**Request for Additional Information No. 335 (4059, 4061)
Supplement 13**

U. S. EPR Standard Design Certification

SRP Section: 03.08.01 - Concrete Containment

Question 03.08.04-10:**Follow-up to RAI Question 03.08.04-5**

**Figure 03.08.04-10-1—Hydrodynamic Pressure on SFP Walls due to
 Seismic Load in -Z (vertical down) Direction**

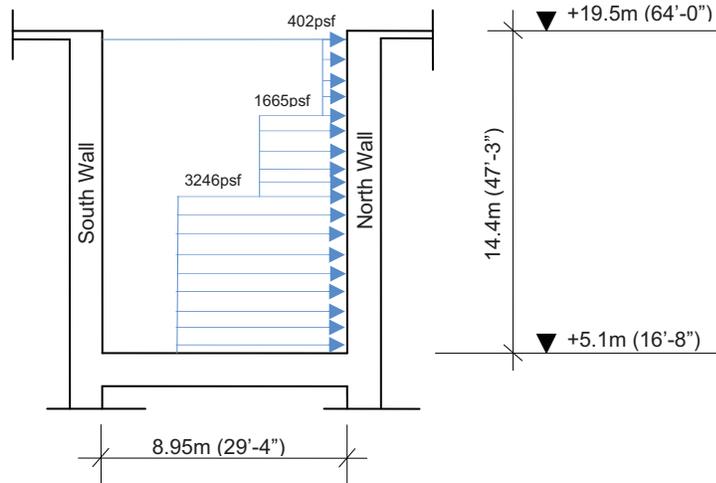
- Hydrodynamic pressure on SFP walls and slab resulting from seismic load in Z (vertical up and down) direction are calculated by multiplying the pool slab ZPA in the Z direction and the mass of the fluid. The SFP floor ZPA is conservatively taken to be an envelope of the entire floor ZPAs in Z direction at elevation +12.14 ft (+3.70 m) and 1.44 g. The magnitude of the calculated and applied uniform pressure on the pool slab is 4222 psf. The pressure on the walls is calculated using 3.28 ft (1m) increments and has a magnitude of 152 psf at the first increment near the water surface, and 4086 psf at the last increment at the bottom of the pool. The loads from each increment are separated into three bands, and the pressure is averaged over the band height, and applied as a uniform wall pressure over the band heights. Figure 03.08.04-10-1 shows the application of the uniform pressure on the walls in the static model.

Figure 03.08.04-10-2—Hydrodynamic Pressure on SFP East and West Walls and Slab due to Seismic Load in +X (East) Direction

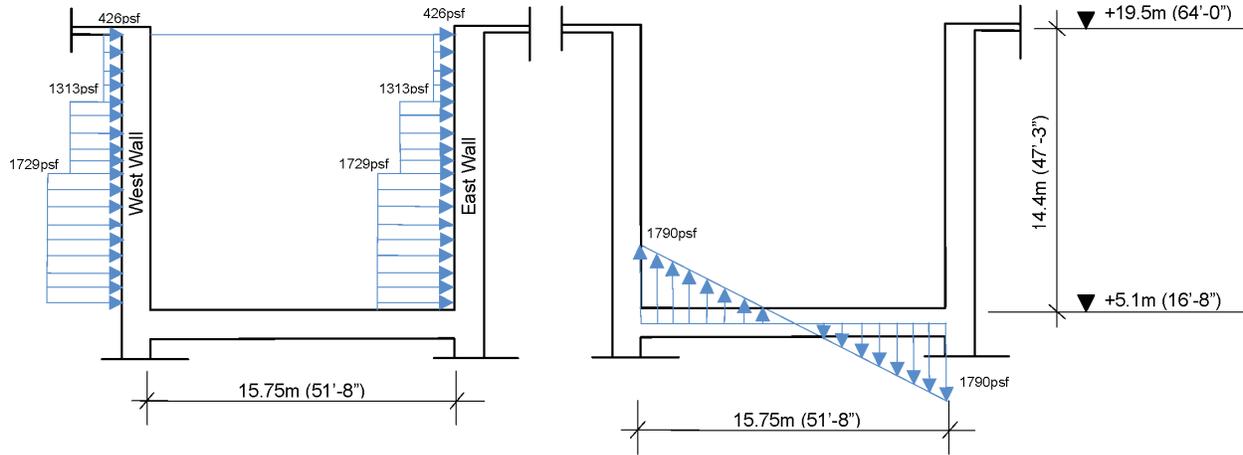
- Hydrodynamic pressure on SFP walls and slab resulting from seismic load in the X (East-West) direction have convective and impulsive pressures that are calculated using the methodology described in TID-7024, Chapter 6 and Appendix F. For the impulsive pressures, the natural frequency of the east and west walls is 33Hz, based on accelerations obtained from the in-structure response spectra (ISRS) using 7 percent damping. An acceleration of 1.0 g from uncracked ISRS at Elevation +48.56 (+14.80 m) was used, which is near mid-height of pool wall. Averaging ISRS accelerations at the top and bottom of the SFP walls result in an acceleration lower than the acceleration at Elevation +48.56 (+14.80 m). The highest seismic amplification is expected to occur at the middle of the walls. The Elevation +48.56 (+14.80 m) ISRS acceleration is appropriate. A comparison of SFP ISRS accelerations is included in the Response to RAI 412, Question 03.07.02-74, Attachment 1.

For the convective pressures, the natural frequency of the sloshing fluid is 0.22 Hz, and the accelerations are obtained from the ISRS at Elevation +48.56 (+14.80 m) using 0.5 percent damping. Convective and impulsive pressures are calculated along the height of the walls and from the centerline of the pool slab using 3.28 ft (1m) increments. Convective and impulsive pressures are summed and applied as a triangular load on the pool slab with zero magnitude at the pool centerline, while the incremental wall pressures are further grouped to three bands. Pressures over the band heights are averaged for application in the NI analytical model as uniform pressure. The load magnitudes for the walls are:

- 145 psf impulsive and 88 psf convective pressure at the top wall segments.
- 1661 psf impulsive and 12 psf convective pressure at the bottom wall segments.

For the pool slab, the maximum pressure at the slab ends is 1778 psf impulsive and 12 psf convective. On average, the convective pressure is approximately 3 percent of the total calculated pressure for the walls and approximately 1 percent for the slab. Figure 03.08.04-10-2 illustrates the uniform pressures and magnitudes applied in the static model. An example of how convective and impulsive pressures are calculated is provided in the Response to RAI 412, Question 03.07.02-74.

Figure 03.08.04-10-3—Hydrodynamic Pressure on SFP North and South Walls and Slab due to Seismic Load in +Y (North) Direction

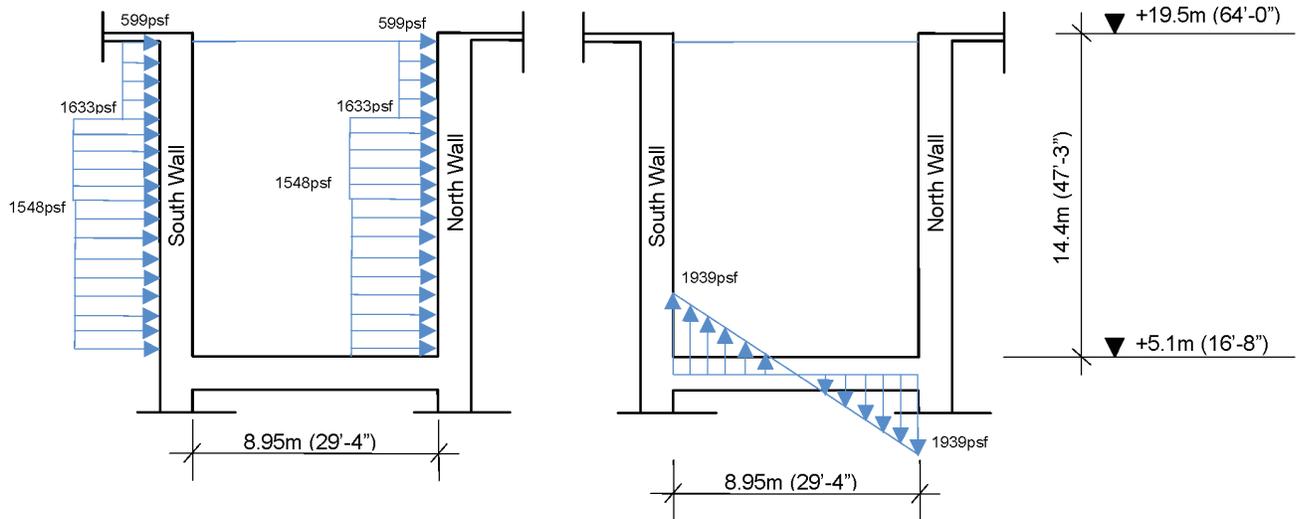
- Hydrodynamic pressure on SFP walls and slab resulting from the seismic load in the Y (North-South) direction are calculated the same as in the X direction, except pressure is applied to the north and south walls. The natural frequency is 19 Hz. The sloshing fluid natural frequency is 0.3 Hz. The load magnitudes for the walls are:
 - 226 psf impulsive and 99 psf convective pressure at the top wall segments.
 - 1510 psf impulsive and 2 psf convective pressure at the bottom wall segments.

For the pool slab, the maximum pressure at the slab ends is 1937 psf impulsive and 2 psf convective. On average, the convective pressure is approximately 2 percent of the total calculated pressure for the walls and less than 1 percent for the slab. Figure 03.08.04-10-3 illustrates the uniform pressures and magnitudes applied in the static model.
